Victorian Society Testimony for May 19, 2026: 144 Greenpoint Avenue (LPC-26-01803); 122-124 Greenpoint Avenue (LPC-26-08566); 555 Carlton Avenue (LPC-25-11236); 215 W. 57th Street, The American Fine Arts Society Individual Landmark (LPC-26-08905); Central Park Scenic Landmark signs (LPC-26-08613); 35 West 83rd Street (LPC-26-02329)

See illustrations below.

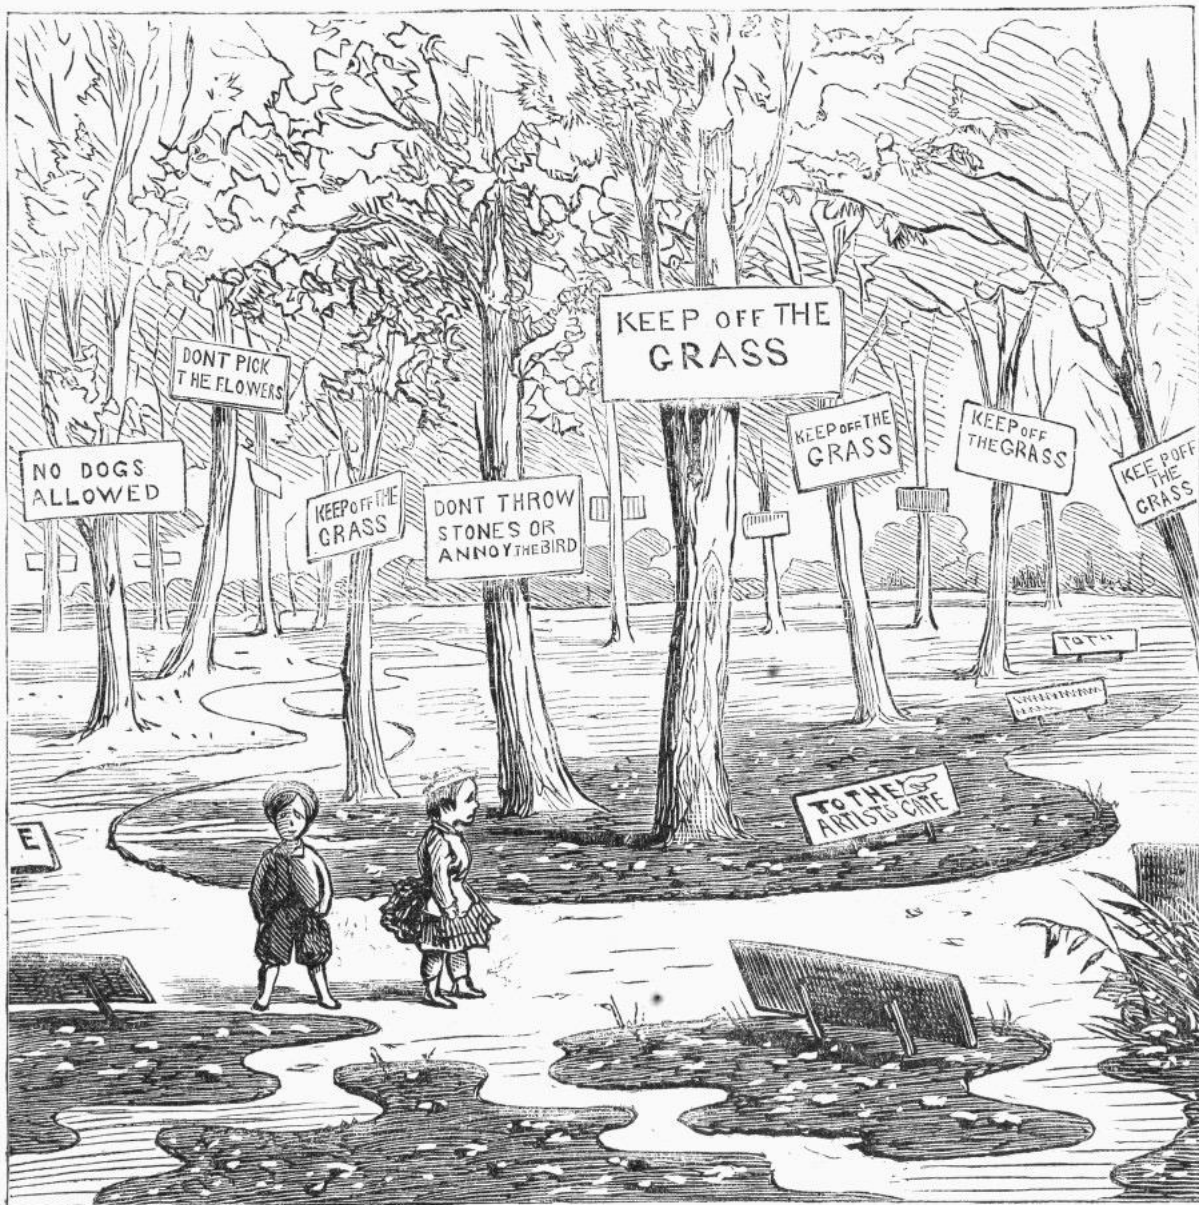
The proposal provides little useful graphic information to illustrate the huge scale of the signs as they will be encountered by visitors, or to describe their materiality and color. Their blank reverse sides have in elsewhere become magnets for graffiti and stickers. The application includes no information on historic signs. We provide in our written testimony examples of rustic and picturesque historic signs from Olmsted parks.
